STATE OF NORTH CAROLINA
DEPARTMENT OF TRANSPORTATION

Subject: **Application Update for an Individual Section 404 and Section 401 Water Quality Certification** for SR 1001 (Connelly Springs Road) from US 321A (Norwood Street) to SR 1712 (Starcross Road) in Caldwell County. Federal Aid Project No. MA-STP-7533(2), Division 11, WBS 34783.1.1, TIP No. U-2211B.

Please see the enclosed Revised Ecosystem Enhancement Program (EEP) mitigation acceptance letter and revised permit drawings for the above referenced project. The enclosed permit drawings replace permit drawings 3, 5, 6, 7 and 8 of 14 from the August application, and include an additional drawing, Sheet 14a of 14. Roadway design plan sheets 6 and 7 are also enclosed.

Revised
 Permit Drawing
 Sheet 3 of 14

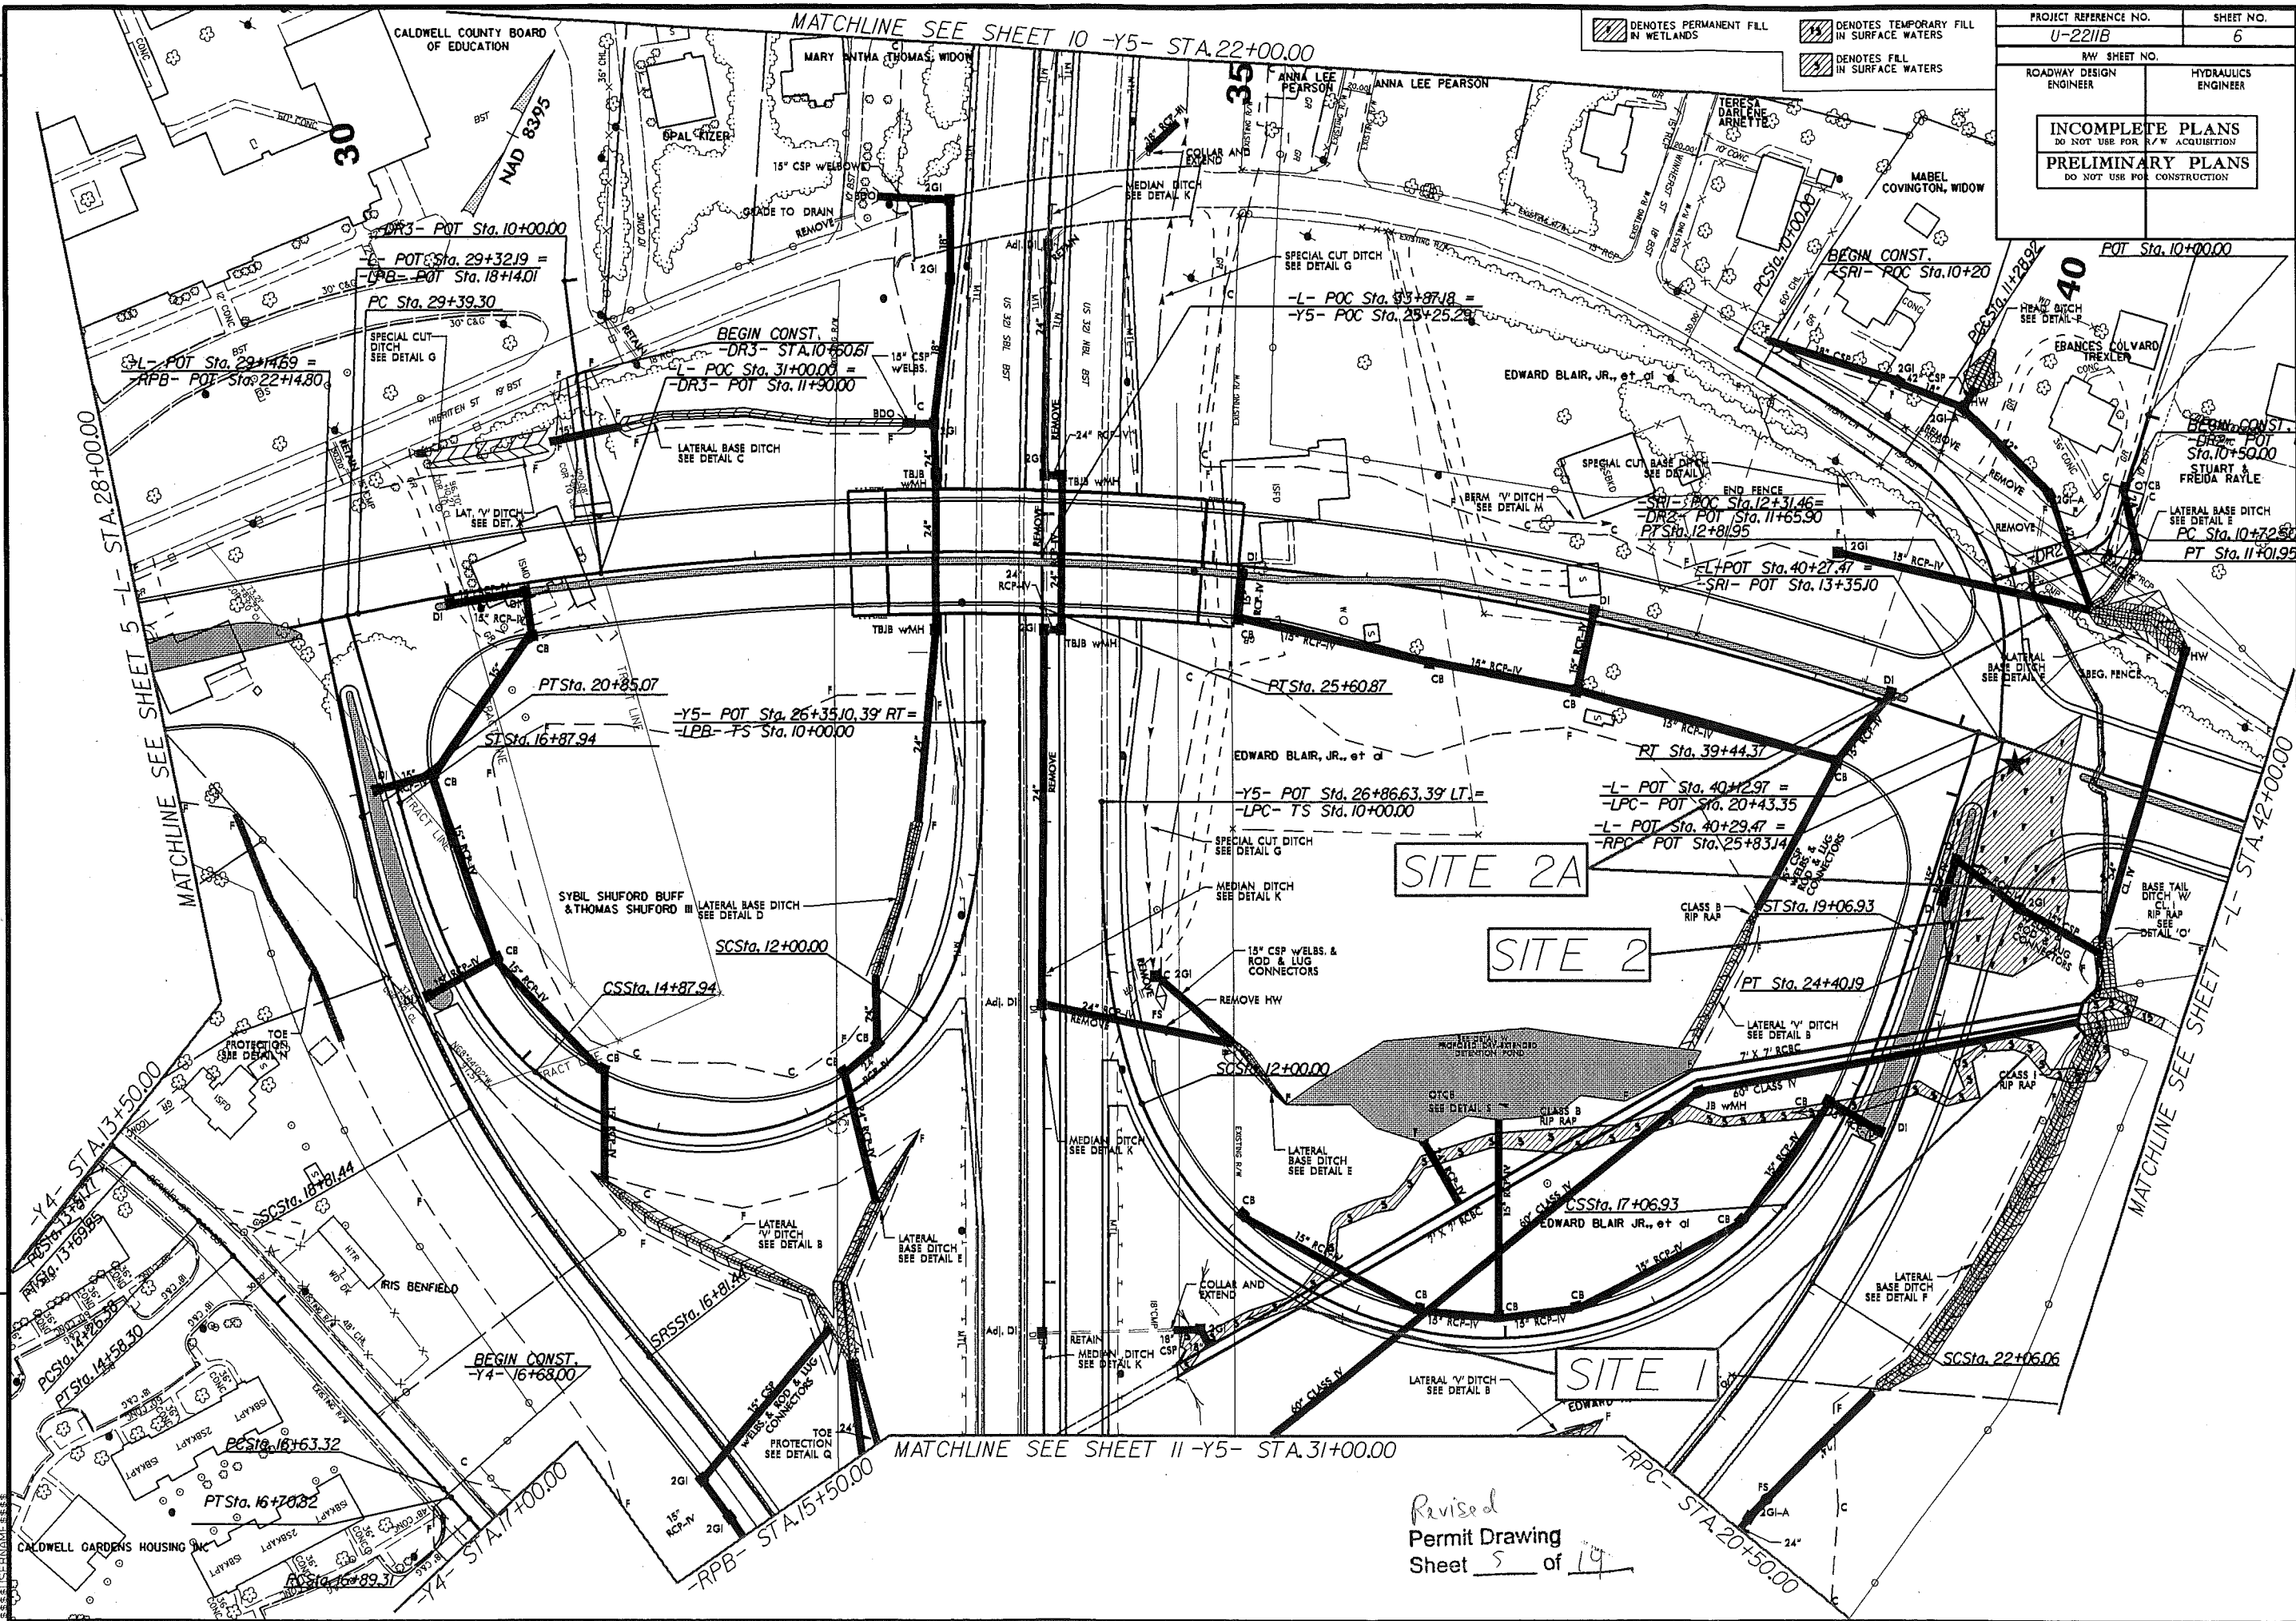
Site No.	Station (From/To)	Structure Size / Type	WETLAND IMPACTS						SURFACE WATER IMPACTS				
			Permanent Fill In Wetlands (ac)	Temp. Fill In Wetlands (ac)	Excavation in Wetlands (ac)	Mechanized Clearing in Wetlands (ac)	Hand Clearing in Wetlands (ac)	Permanent SW impacts (ac)	Temp. SW impacts (ac)	Existing Channel Impacts Permanent (ft)	Existing Channel Impacts Temp. (ft)	Natural Stream Design (ft)	
1	-Y5- 28+22 LT to 32+83 RT	7' x 7' RCBC (transitions to 7' x 8' RCBC with Baffles)							0.49	<0.01	922	34	
1	-Y5- 28+22 LT	Bank Stabilization							<0.01		38		
1	-Y5- 32+83 RT	Bank Stabilization							0.01		40		
2	-RPC- 23+77 to 24+46 RT	Roadway	0.24						0.02		297		
2A	-RPC- 23+77 to SR1 12+30	Roadway/54" RCP							<0.01		16		
3	-L- 46+38 to 46+54 RT	Bank Stabilization							<0.01	<0.01	42	19	
4	-Y9- 11+95 RT/LT	8'x8' RCBC							0.01		102		
4	-Y9- 11+95 RT/LT	Bank Stabilization							0.02	<0.01	153

5	-L- 51+44 to 52+41 LT	54" RCP											
TOTALS:			0.24						0.55	0.01	1610	53

Revised
Permit Drawing
Sheet 5 of 14

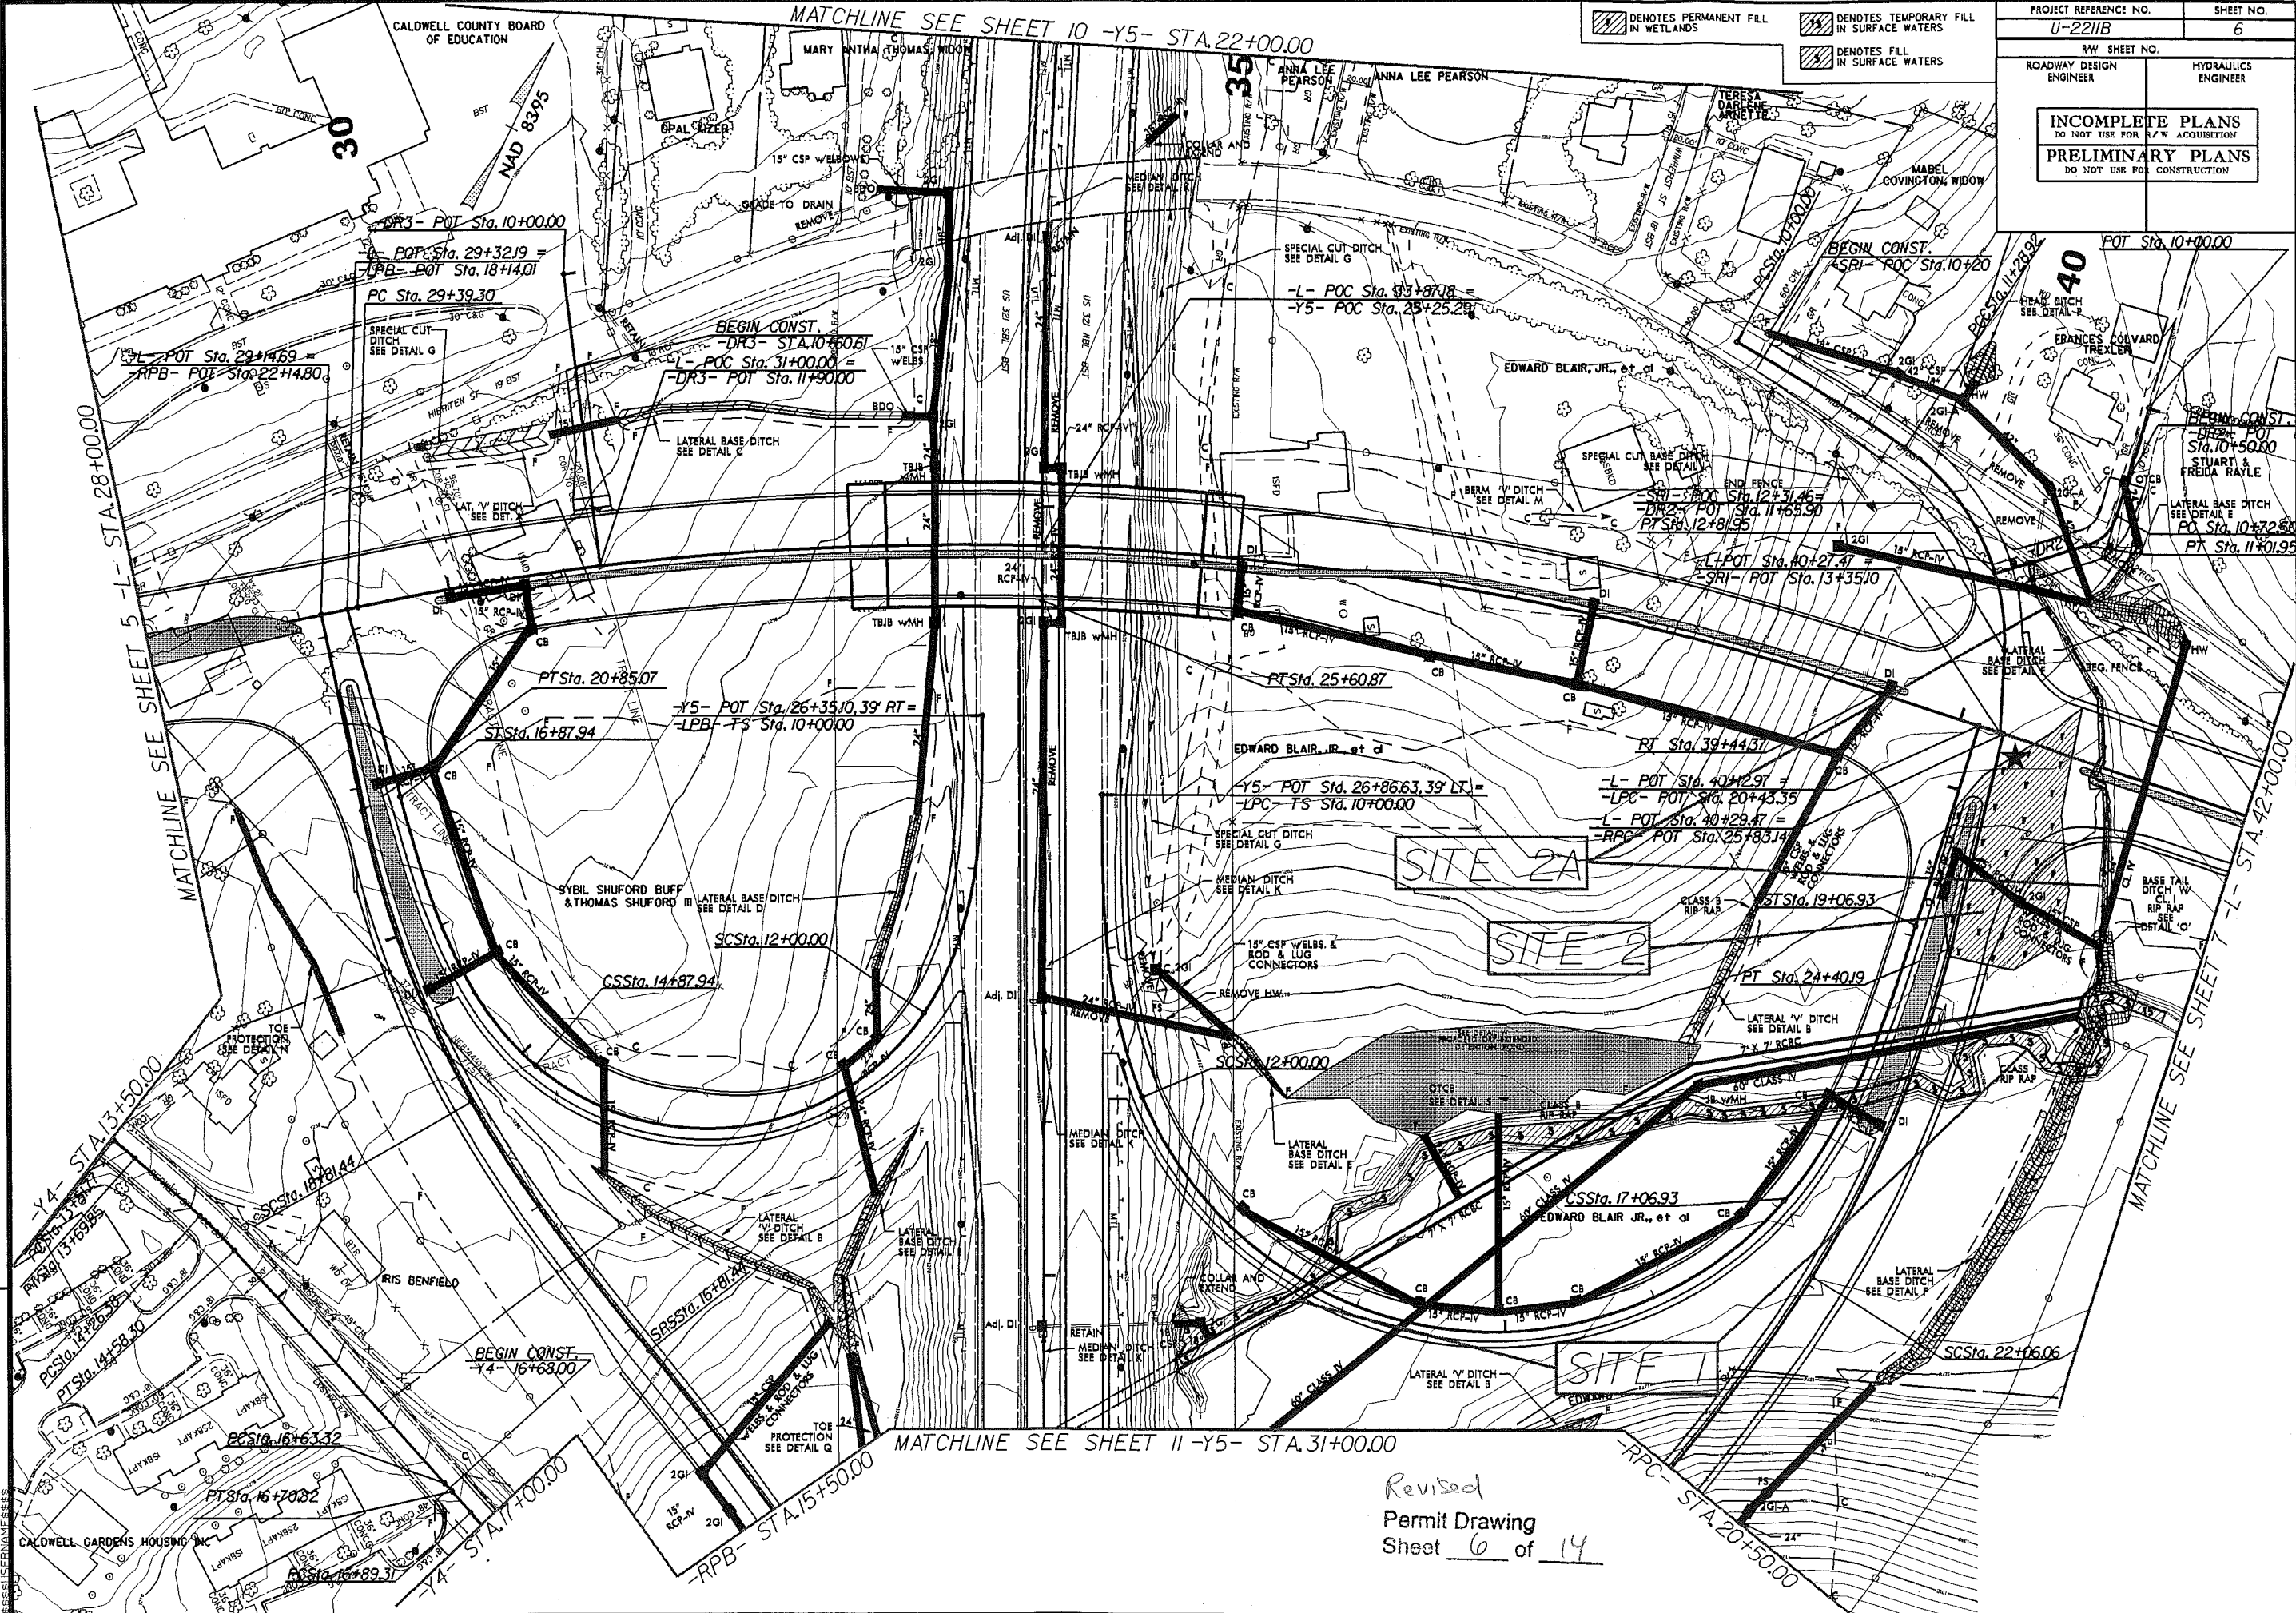
Permit Site 2a: A new jurisdictional feature, UT3 to Gunpowder Creek, has been identified within the project footprint since the August 2011 permit application. This channel begins at the outlet of an existing 24" corrugated metal pipe (CMP) under Hibriten Drive and is located just east of wetland W1. All 297 linear feet of UT3 will be impacted by the proposed new interchange at US 321 as a result of roadway fill.
